ADDENDUM

MEETING OF THE PLANNING COMMITTEE

WEDNESDAY 14th December 2022

PLANNING APPLICATION: 22/00271/F - REIGATE GRAMMAR SCHOOL REIGATE ROAD REIGATE SURREY

Appendix A

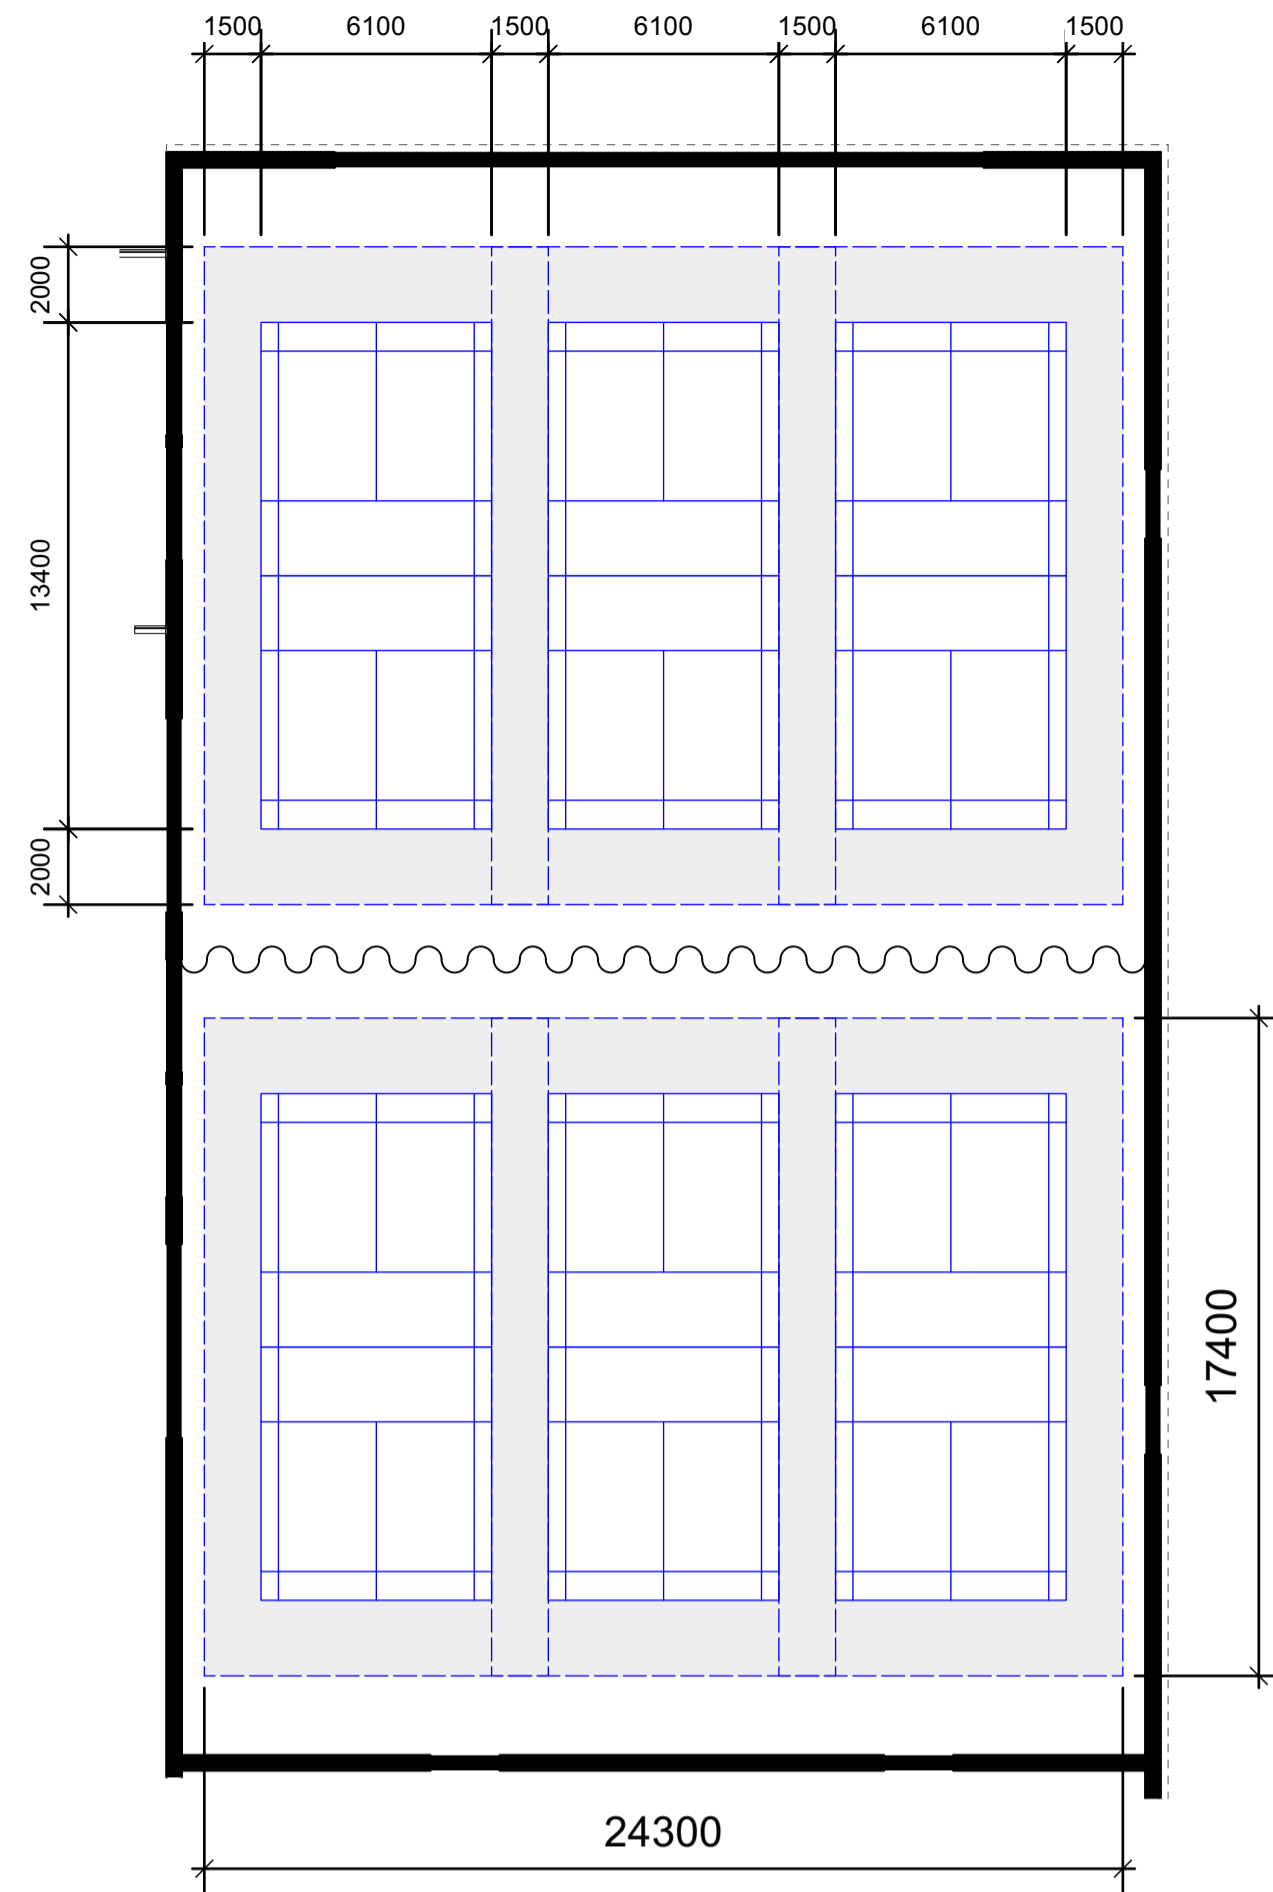
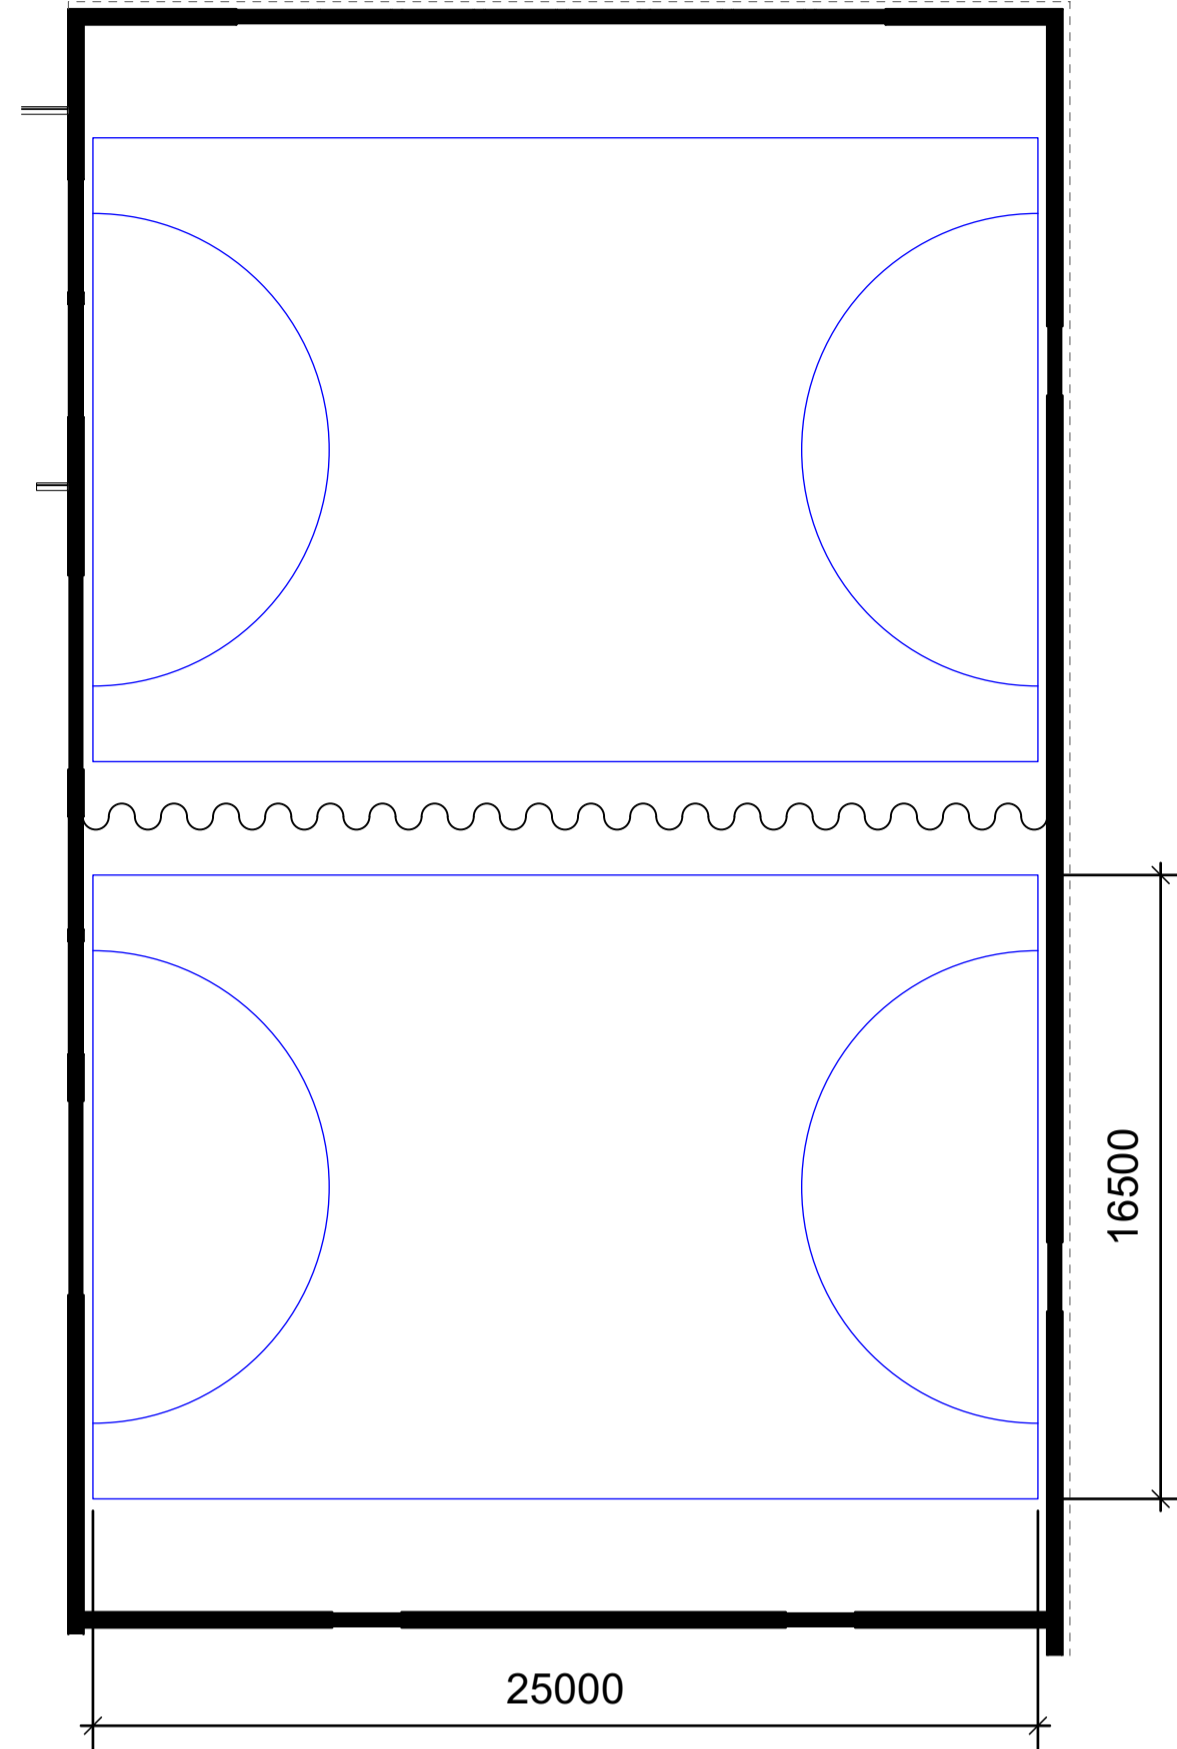
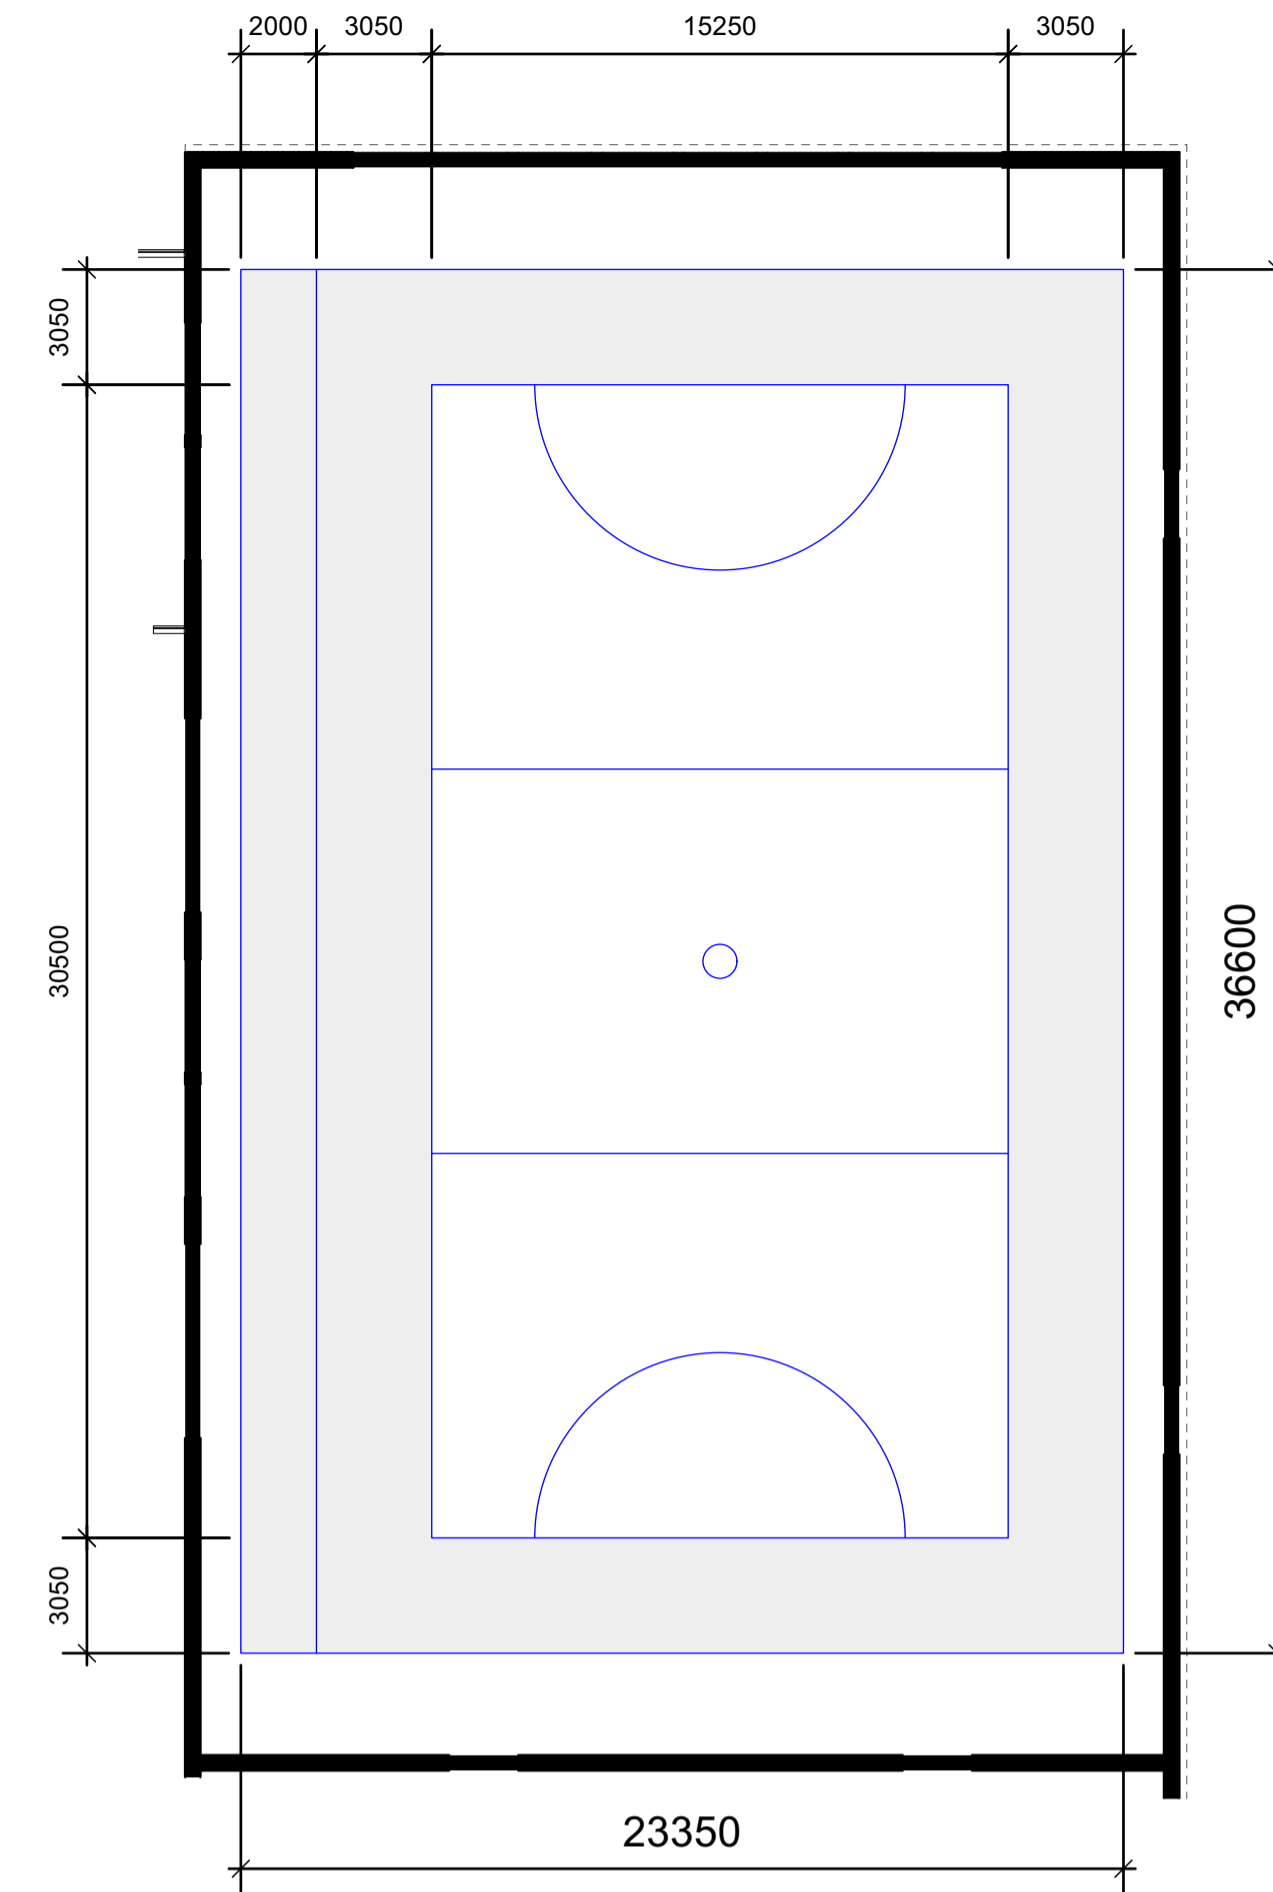
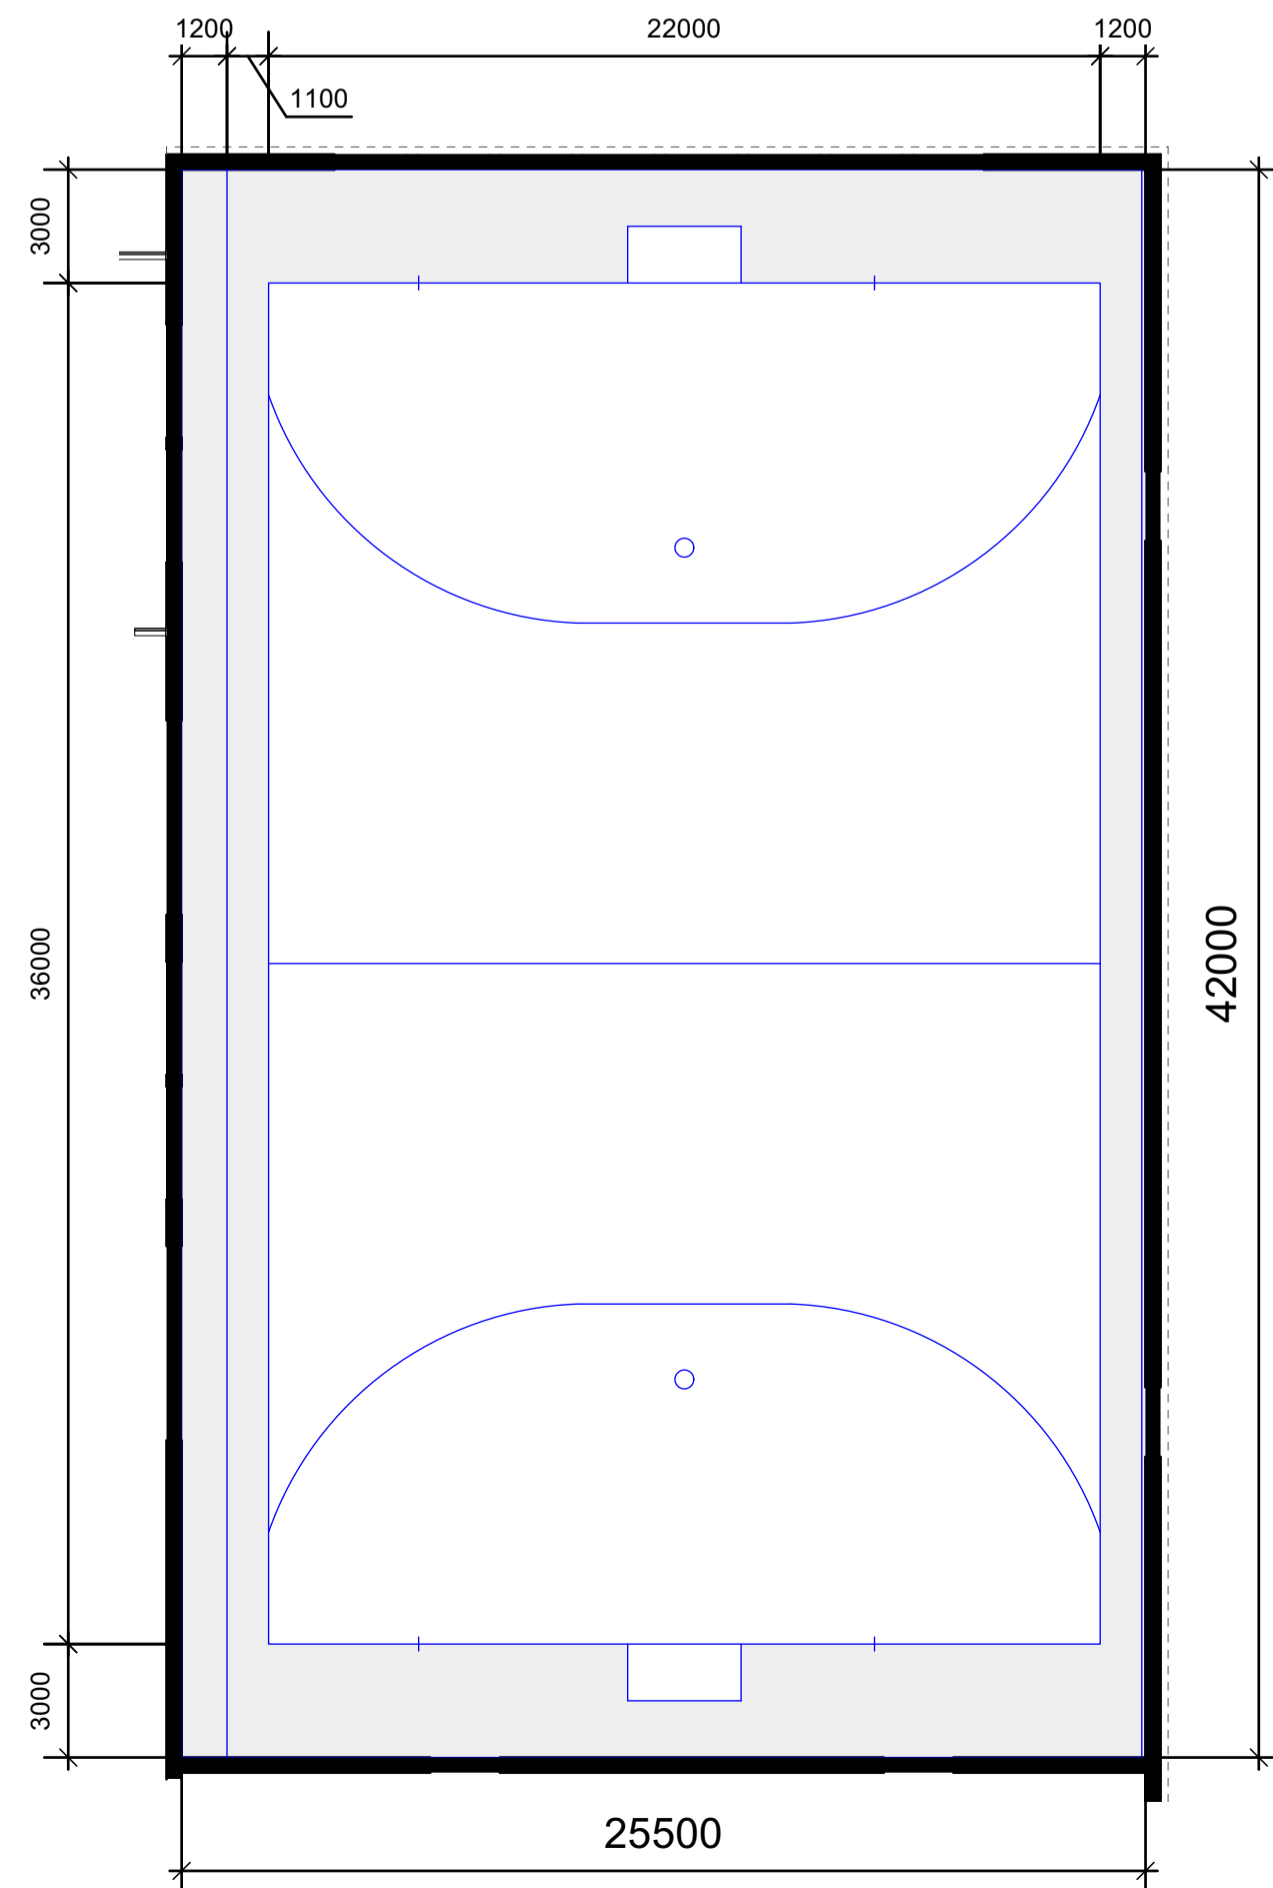
25.5m wide x 42m long x 8m high (approx. 7.7m useable). **Appendix A** shows the size of the sports hall, sized to Sports England requirements for a range of sports.

Sports hall sized to Sports England requirements for a range of sports.

Sports Hall height to be 7.7m
